Title: Advisory Committee on Reactor Safeguards  
APR 1400 Subcommittee: Open Session

Date: Wednesday, February 21, 2018

Chapter 9 Auxiliary Systems (Open) KHNP

Fig. 4-2 Deep Drop Away from  
a Pedestal

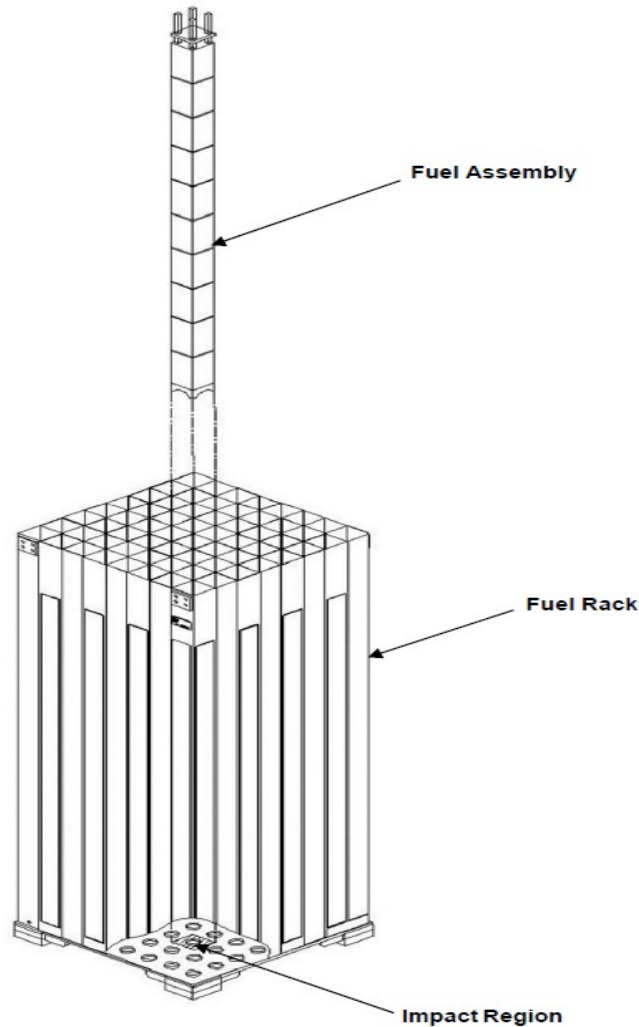
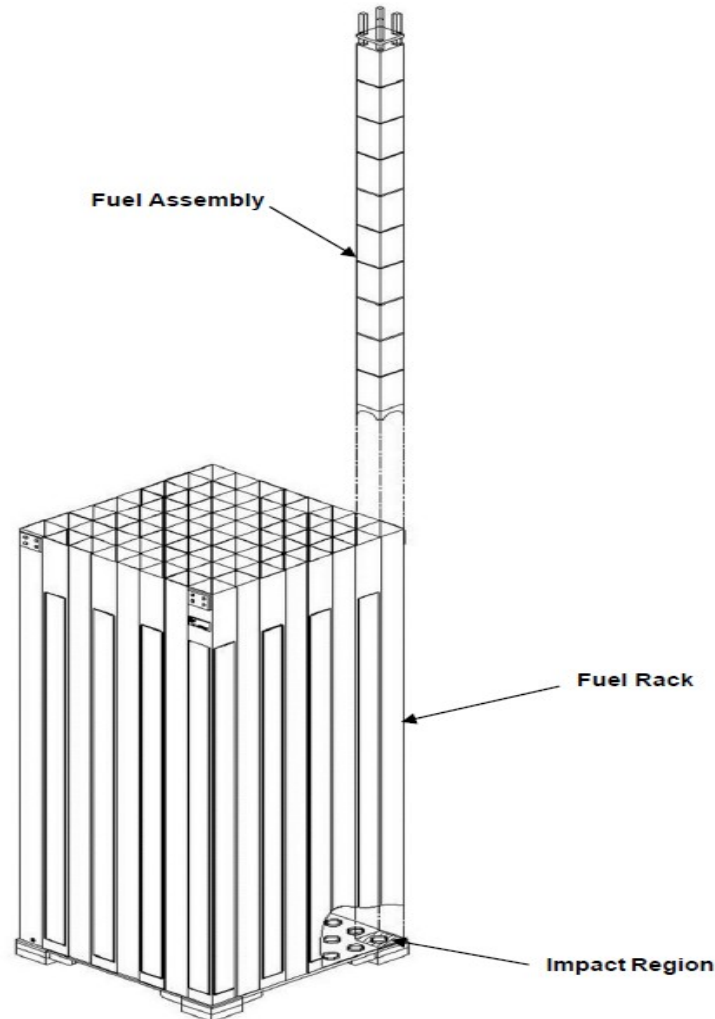
11                  MEMBER SKILLMAN:   Let me ask this question  
12      on the next to the last carrot under analysis, the slide  
13      reads as follows, "Demonstrated that the impact of the  
14      straight, deep drop of the fuel assembly on a specific  
15      location does not cause any significant deformation  
16      to the base plate."

1 me clarify what is meant here. So they --- when the  
2 plate is fully loaded with the fuel, the base plate,  
3 you would expect, right, kinetics. The maximum  
4 deflection will be at the center, simply supported here.
